NUMBER: 08-183-22

This bulletin supersedes Technical Service Bulletin 08-174-21 REV. B, date of issue December 24, 2021, which should be removed from your files. All revisions are highlighted with **asterisks**** and include converting to an RSU, an additional symptom/condition and LOP.**

Flash: Telematics Box Module (TBM) Updates

2021 (WL) Jeep Grand Cherokee

Fig. 1
Error Message

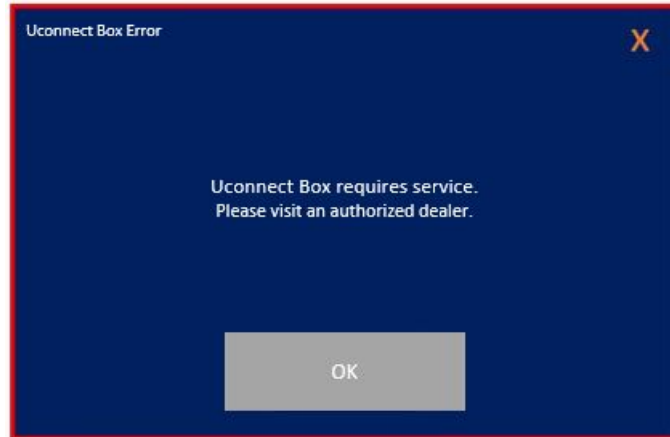
- ****Message displayed on the radio screen, "Uconnect Box requires service. Please visit an authorized dealer." (Fig. 1) , with no active or stored Diagnostic Trouble Codes (DTCs) set by TBM or Occupant Restraint Controller (ORC).**

1. ****Is the vehicle on the RSU VIN list?**
 - YES>>>Proceed to [Step 2](#).
 - NO>>>Proceed to [Step 3](#).
2. Does the TBM have the latest software already installed?
 - YES>>>This bulletin has been completed, use inspect LOP (18-20-37-9A) to close the active RSU.
 - NO >>>Proceed to [Step 3](#).**
3. Reprogram the TBM module with the latest software. Detailed instructions for flashing control modules using the wiTECH Diagnostic Application are available by selecting the application's "HELP" tab.
4. Wait two minutes after the TBM flash has been completed.
5. Reset the Electric Power Steering (EPS) - Guided diagnostics menu -> ECU reset -> EPS, Click Continue and follow wiTECH prompts.
6. Clear all DTCs that may have been set in any module due to reprogramming. The wiTECH application will automatically present all DTCs after the flash and allow them to be cleared.
